#### HISTORIC LANDMARK COMMISSION

# PERMITS IN NATIONAL REGISTER HISTORIC DISTRICTS DECEMBER 17, 2018 NRD-2018-0069

315 E. 6th Street Sixth Street Historic District

Rooftop structure at the Blind Pig, 315-17 E.  $6^{\rm th}$  Street (December, 2018)

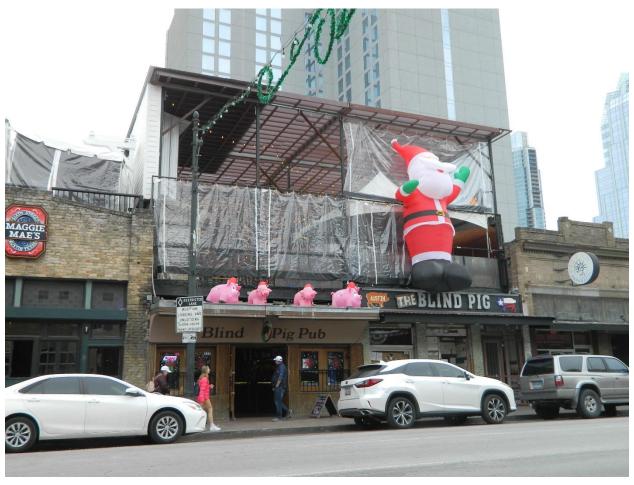
The buildings at 315 and 317 E. 6<sup>th</sup> Street were modified years ago, and would not be contributing to the character of the historic district.

Recommend that the applicant continue to consider means of reducing the visual impact of the rooftop use that more fully comply with the architectural design guidelines for the historic district. Staff appreciates that the applicant proposes to reduce the existing impact of the rooftop use, but the project is still not in line with the architectural design guidelines for the district. Setting the rooftop use back a little further would go a long way towards complying with the intent of the guidelines to maximize the articulation of the historic buildings and minimize new construction, but the applicant's proposal is definitely a step in the right direction.
